SERVICE INSTRUCTION

AMENDMENT ON REDUCTION GEARBOX

FOR ROTAX® 2-STROKE UL AIRCRAFT ENGINES

SI-2ST-007 R2

2.3) For distinguishing the cone sleeve

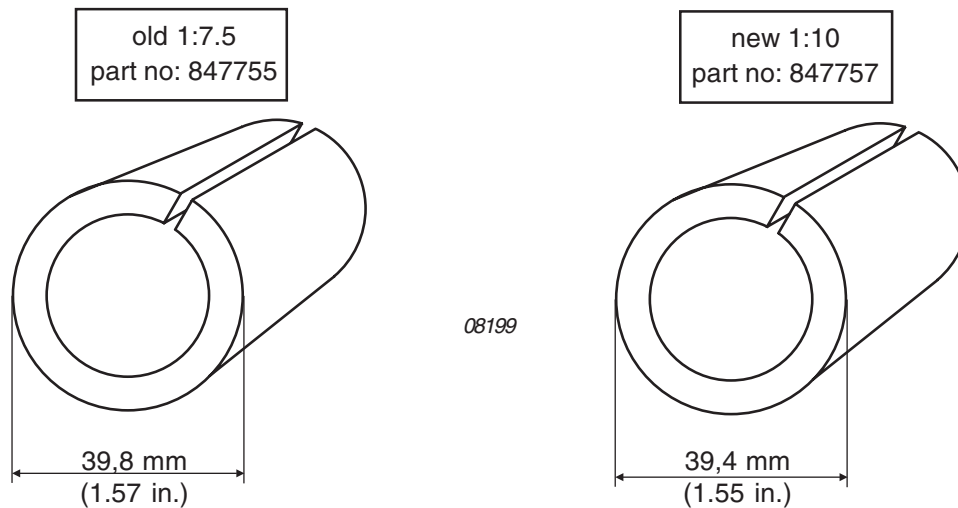
Introduction of a new cone sleeve with lower cone angle.
Standardisation of tightening torque for old and new cone types.

The cone sleeves can be distinguished according to following drawings. To prevent measurement mistakes the diameter has to be determined as follows:

Single parts of the gear set can be matched to the cone versions as follows:

gear ratio	C gearbox		E gearbox	
	old 1:7.5	new 1:10	old 1:7.5	new 1:10
	gear set part no.		gear set part no.	
2.62	886211	886280	886750	886751
3.00	886213	886282	886752	886753
3.47	886215	886284	886754	886755
4.00	886217	886286	886756	886757
